Addendum #1

PROJECT: Wells Fargo Greely 6835 10th Street Greely, Colorado 80634

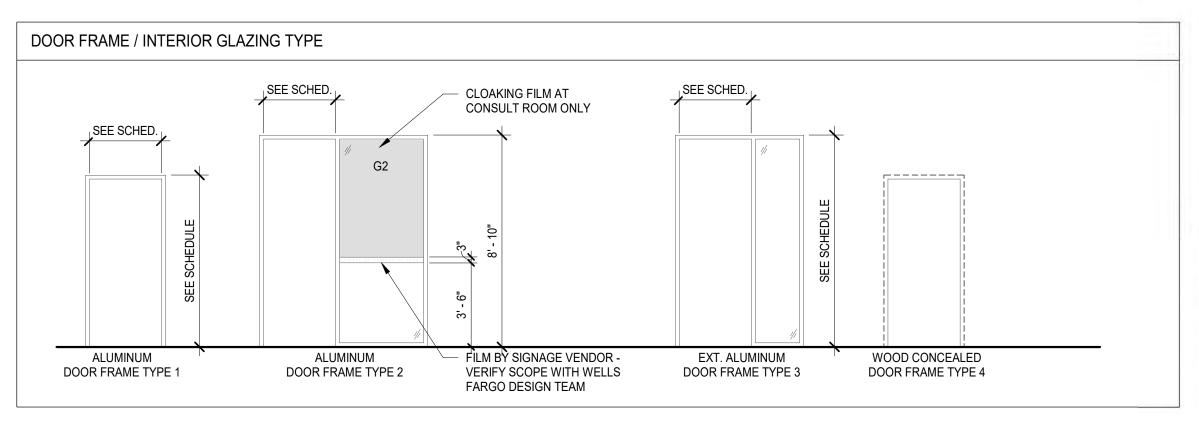
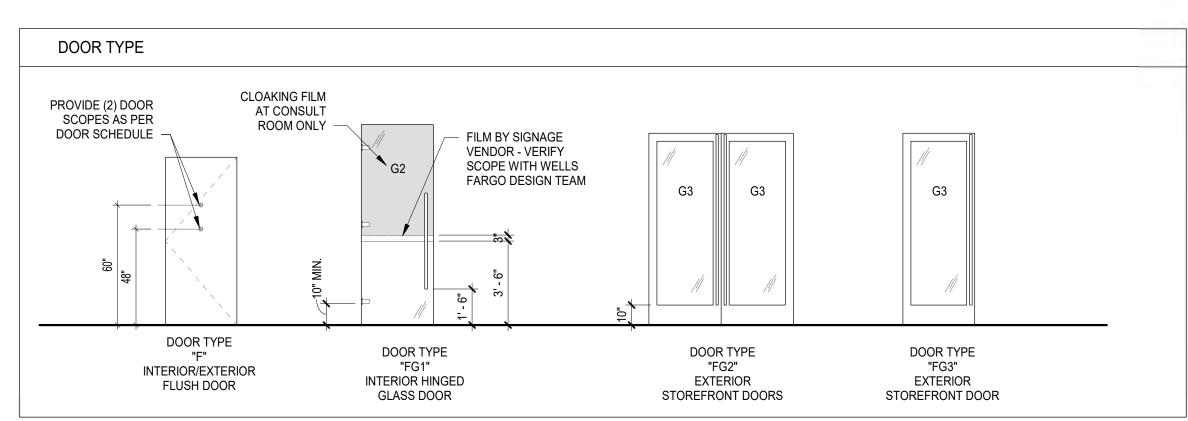
- o Sewer \$23,000
 - *Contact City of Greeley for Building Permit Cost since it is based on your bid amount.
- 1.6 Clarification to Sheets Sheet G0.01 and G0.11 Door 121 is to be a BR Door with new hardware scheduled 9.05. The contractor to coordinate that correct laminate finish is ordered.

Door schedule is called out for Door Types FG5 and FG6 for the interior doors but there is no Door Type FG5 and FG6. Should these be type FG1?

Door Types indicated as either FG5 or FG6 are to be FG1.

ELECTRICAL PLAN

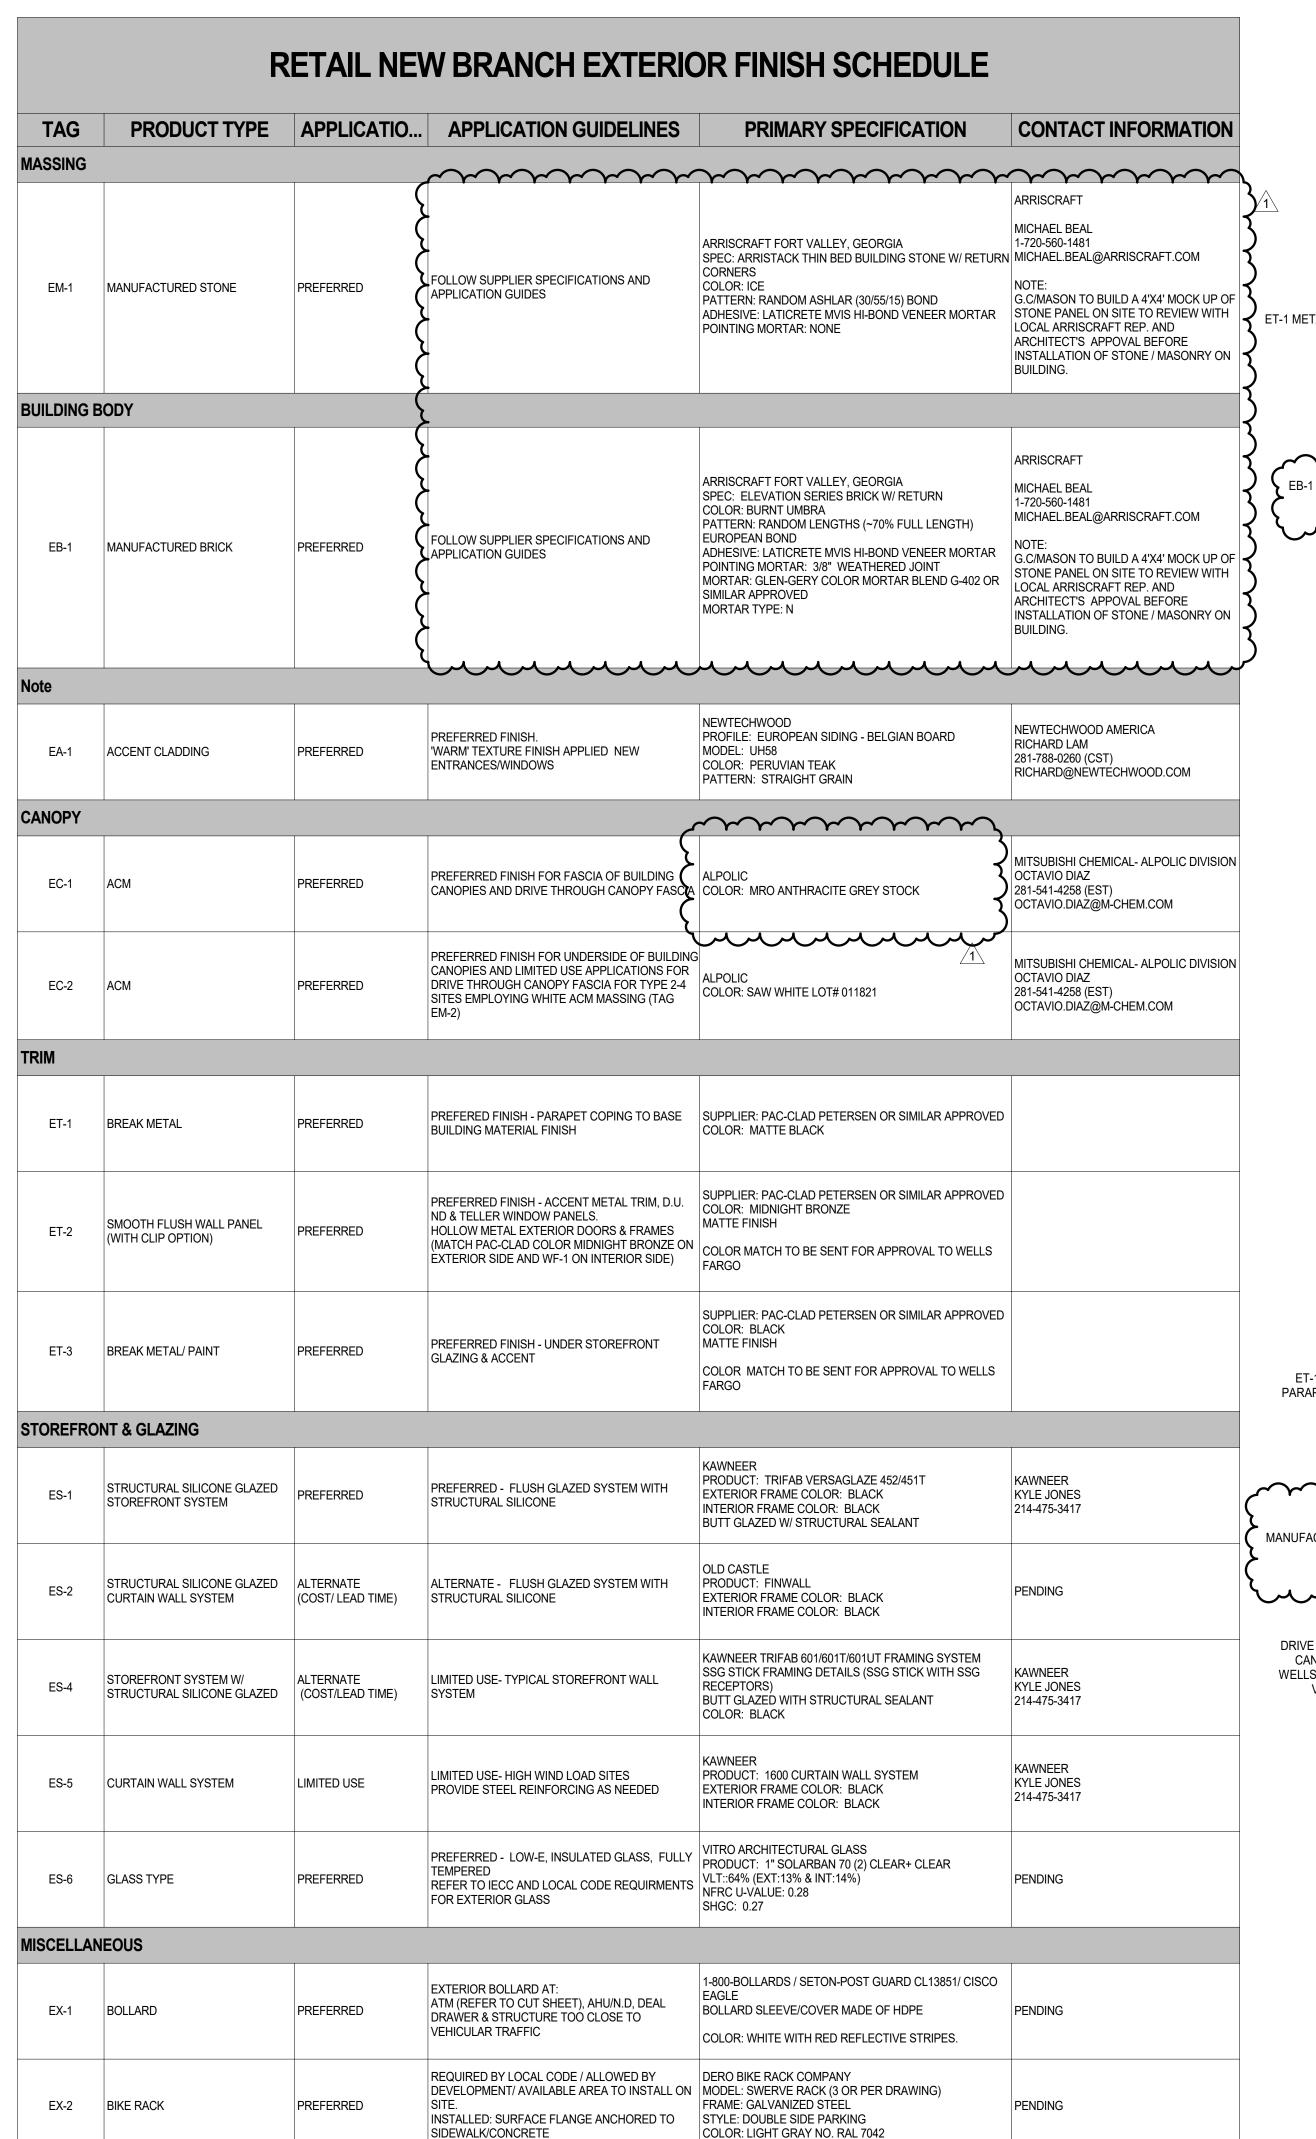
- 1.7 Clarification to Sheet A1.04 Electrical Plan Floor outlets identified as either a floor box or conduit stubbed into millwork.
- 1.8 Exterior Finish Revision Architectural Sheets A201, A2.02, A3.10 A3.13, A4.00 A4.03, and Structural Sheets S0.50, S0.51, S1.02, S1.03, S5.01 for the material revisions to the building façade by the client.

STORM PROFILES
SHEET NO.

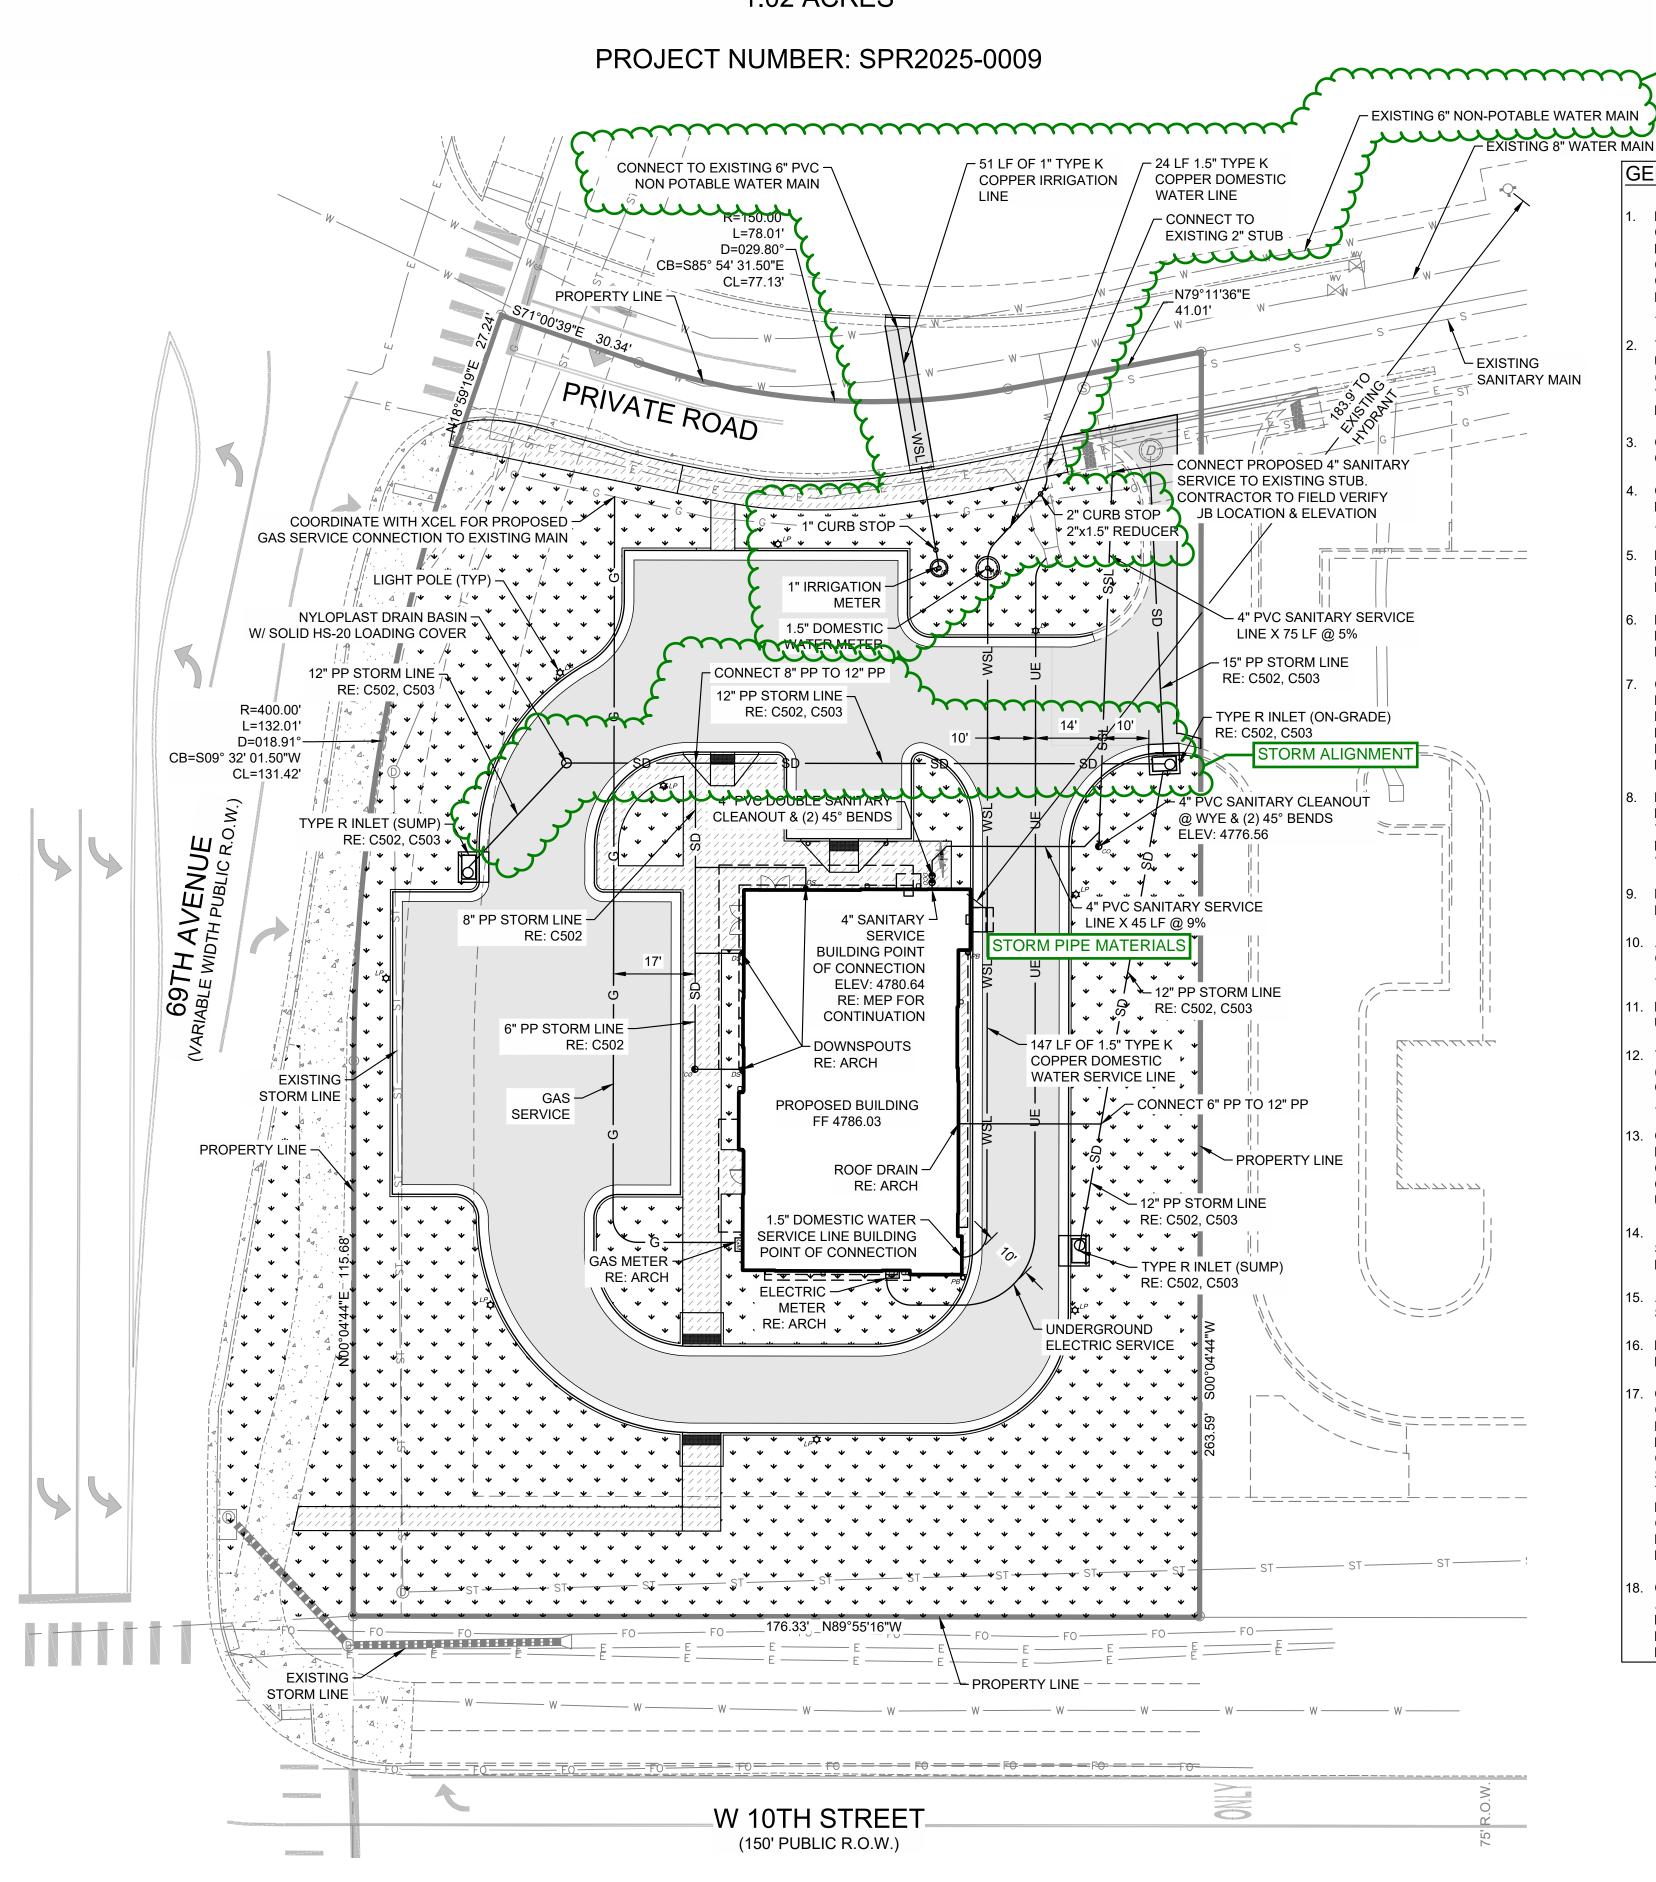
- 1.9 Civil Plans Revised sheets C300 thru C303, C400, C500 thru C503, and C600 with City Comments to include in Bid.
- 1.10 Landscape Plan Revised sheet 6 of 15 with City Comments to include in Bid.
